## Cree LED HB SMD Product Change Notification

PCN Reference Number: CreeLED-PCN-5323

Date Issued: December 8, 2022

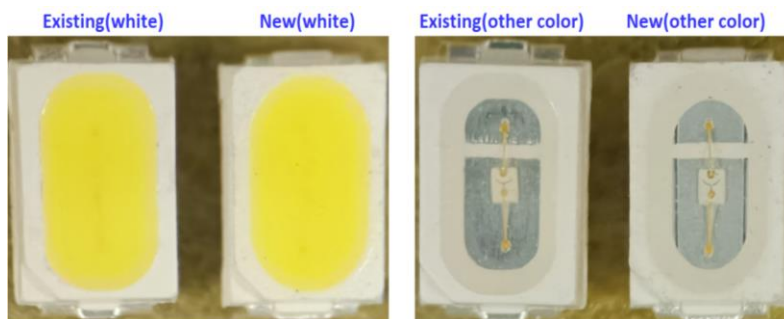
This change introduces the use of a lead frame from an alternative vendor. The visual appearance of the LED will change. Examples of the current and new visual appearances are shown below.
